MEADOWBROOK

AN ADDITION TO SEDGWICK COUNTY, KANSAS

RE: SUB 2003-115 -- One-Step Final Plat of Meadowbrook Addition

CASE NUMBER: SUB 2003-115 -- MEADOWBROOK ADDITION

MEADOWBROOK
AN ADDITION TO SEDGWICK COUNTY, KANSAS

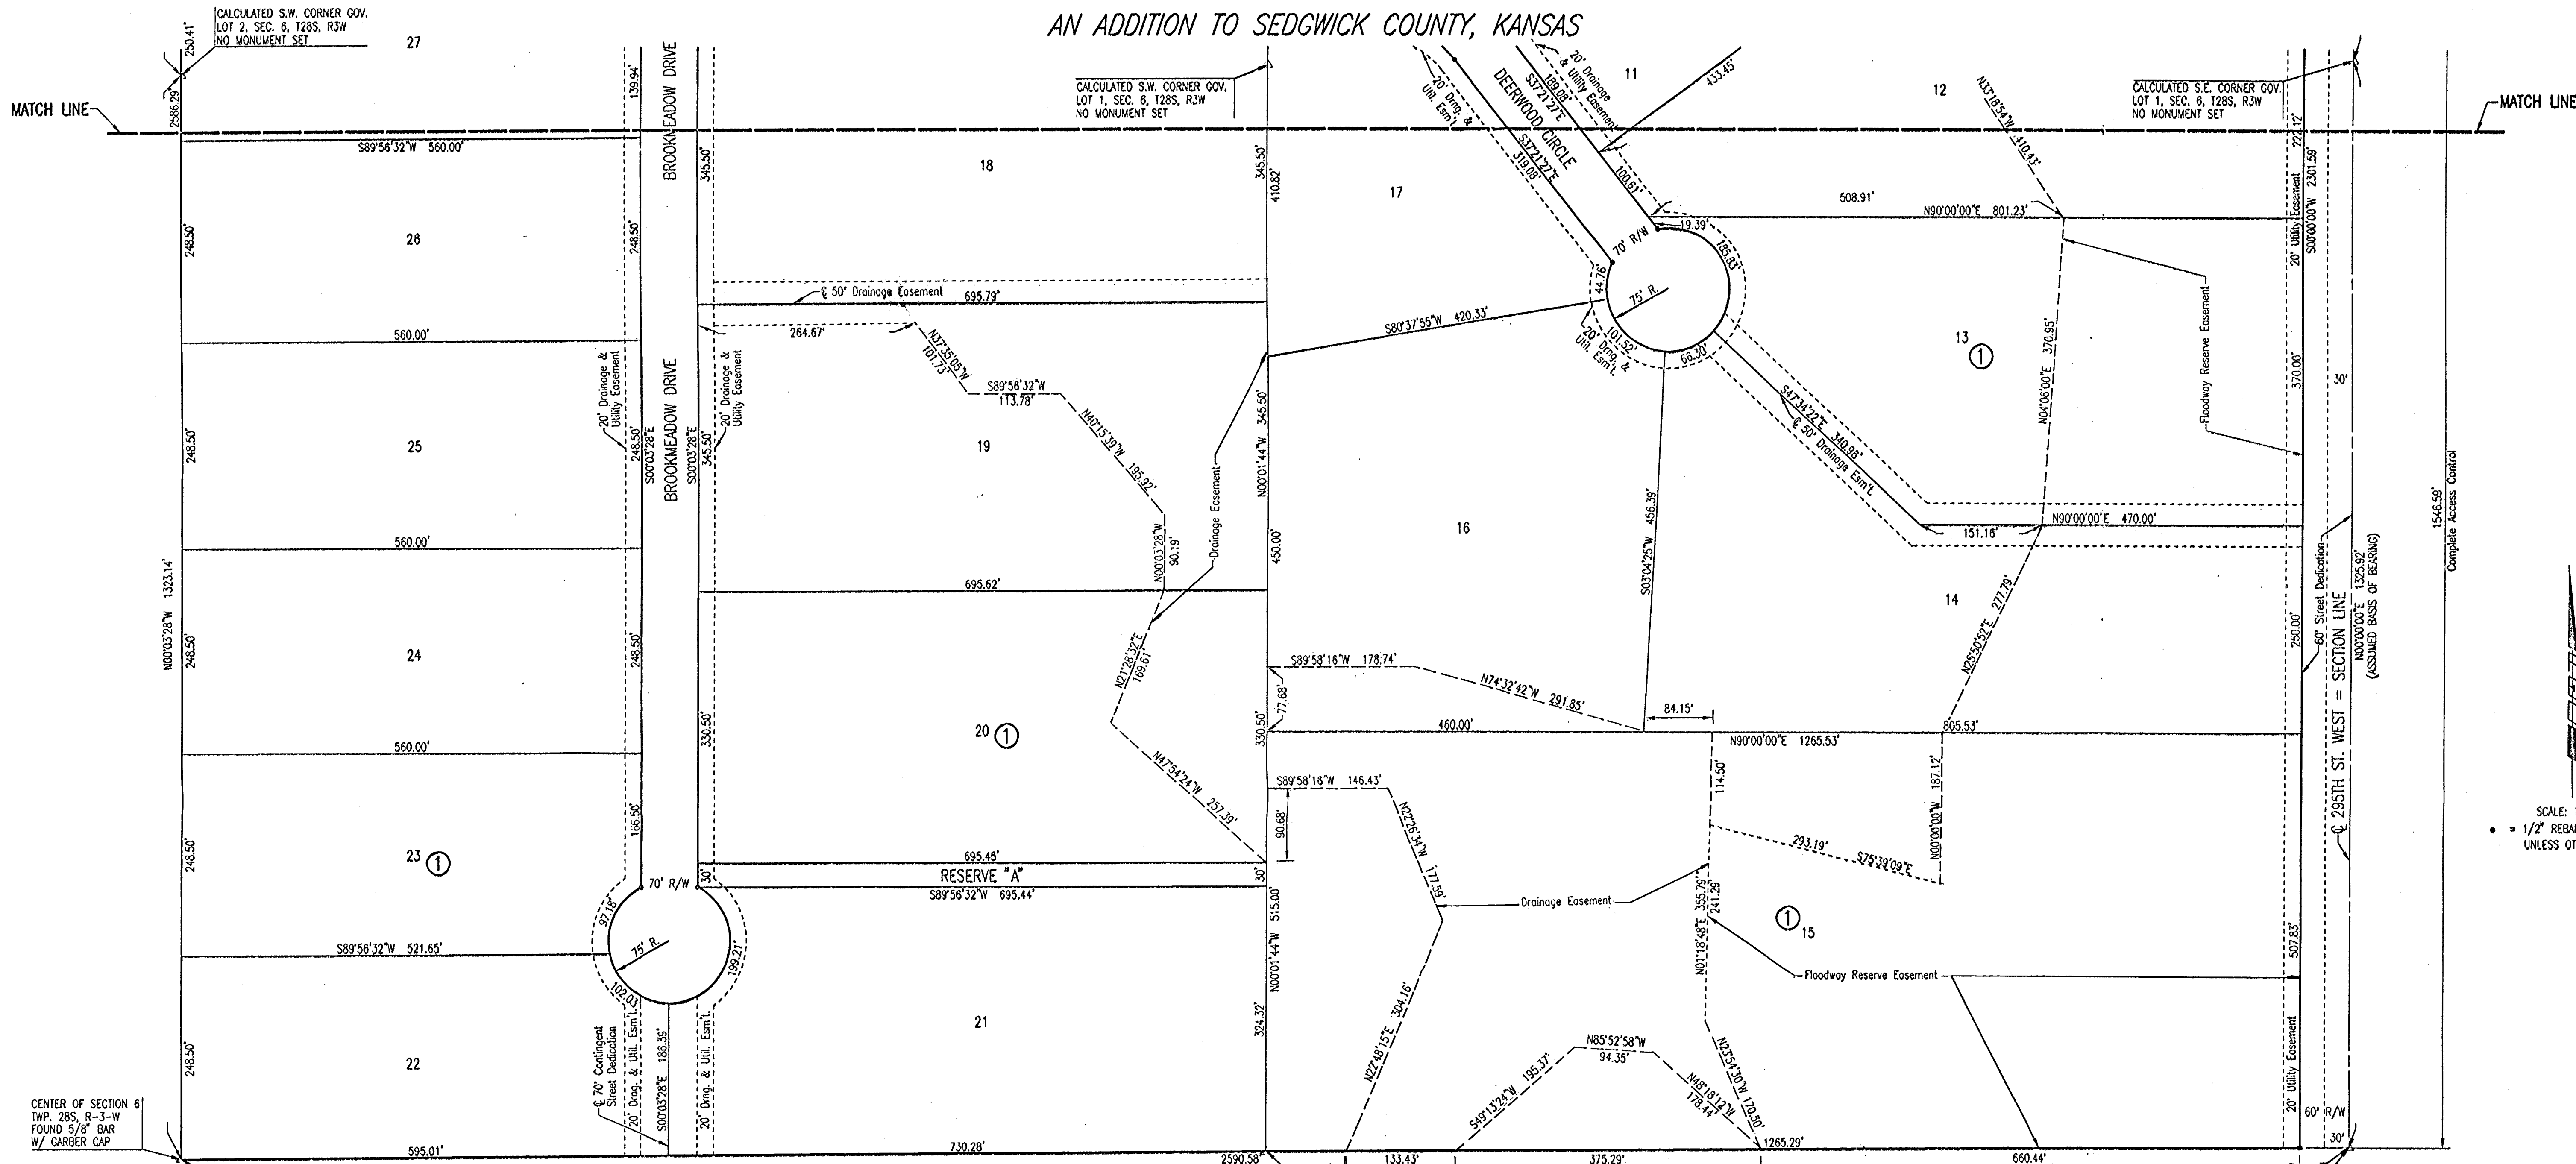
- A. Since neither sanitary sewer nor municipal water is available to serve this property, the applicant shall contact **County Code Enforcement** to find out what tests may be necessary and what standards are to be met for approval of on-site sewerage and water wells.

- C. **County Engineering** needs to comment on the status of the applicant's drainage plan. *A flood study is needed with encroachment routine and hydrology. DWR permits are needed. The Applicant will need to submit letter to FEMA for map revision to reflect the change in flood plain. The drainage plan needs to address offsite drainage coming in from the west and from the south, as well as terraces. Additional drainage easements or floodway reserve may be required. Minimum pads are needed based on flood study and drainage plan.*

- D. The floodplain should be covered by a floodway reserve agreement. The plat's text shall denote the creation of the floodway reserves in addition to including the standard floodway language.

- E. **County Engineering** needs to comment on the access controls. The plat denotes six openings along 23rd St. South and five openings along 295th St. West. *Complete access control is required along 23rd St. South for Lot 5, Block 1 and Lot 32, Block 1. Additional access controls need to be determined upon discussion with County Engineering prior to MAPC meeting.*

- F. In accordance with Access Management Regulations, complete access control is required for arterials intersecting with collectors/local streets. Complete access control of 75 feet is needed along Brook Meadow Drive from 23rd St. South.

- G. A corner clip is needed at the intersection.
- H. Per Sedgwick County Fire Department, access drives to any structure in excess of 150 feet from the edge of the roadway will need to be installed prior to final framing inspection, preferably before the start of any above grade construction work. Such drive to be installed according to fire department specifications: (1) Twenty feet of drivable surface is provided the entire length of the access drive designed to withstand the weight of fire apparatus in inclement weather with provisions for turning fire apparatus around. (2) To meet fire department specifications, the surface will need to be an all-weather material consisting of rock or gravel, ground asphalt, laid asphalt or concrete. It is to be applied a minimum of 4 inches in depth consistently over the entire width and length of the driving surface (gravel is prone to problems during extended periods of rain or snow and should be used with caution unless a good solid compacted base has been installed).

- I. A covenant shall be submitted regarding Reserve A platted for private drive purposes, which sets forth ownership and maintenance of the private drive, and future reversionary rights of the reserve to the lots benefiting from the reserve.

- J. The applicant shall guarantee the installation of the proposed streets. Cul-de-sacs will require 36' wide rock streets.
- K. The Applicant has platted a contingent dedication of street right-of-way extending to the west and south property line. On the final plat tracing, the contingent dedications of right-of-way need to be referenced in the plat's text. The language should state that "the contingent street dedications are hereby contingently dedicated as street right-of-way to become effective upon the platting of any adjacent subdivision having a street connecting thereto. The costs of constructing said street, are to be borne by the person(s) or agency that owns said adjacent subdivision."

- M. County Fire Department needs to comment on the street length of Deer Wood Circle (1,400 feet). The Subdivision Regulations limit rural cul-de-sacs to 1,200 feet in length unless a stub street connection or contingent street dedication is provided for future access to adjoining tracts. The street length is approved.

- N. The signature line for the County Commissioners Chairman needs to reference "Tim R. Norton".
- O. GIS needs to comment on the plat's street names. GIS has requested that the street names be revised to "Deerwood Cir" and "Brookmeadow Dr".

- P. For lots fronting on cul-de-sacs, the lot frontage is required to be 50% of the required lot width (200 feet). Lot 15, Block 1 does not meet this 100-ft frontage requirement. A modification needs to be approved by MAPC.

- Q. The Subdivision Committee requested the platting of internal utility easements to serve future sewer and water extensions.
- R. The platlor's text shall include language that a drainage plan has been developed for the plat and that all drainage easements, rights-of-way, or reserves shall remain at established grades or as modified with the approval of the applicable City or County Engineer, and unobstructed to allow for the conveyance of stormwater.

- Z. The representatives from the utility companies should be prepared to comment on the need for any additional utility easements to be platted on this property. Westar Energy and SBC have requested additional easements.

At the regular meeting of the Metropolitan Area Planning Commission on October 23, 2003, the above captioned plat was considered. The action of the Planning Commission was to approve the plat as recommended by the Subdivision Committee, subject to the conditions stated in our letter dated October 17, 2003, with the addition of the following to Item E: County Engineering has approved the proposed access Controls.
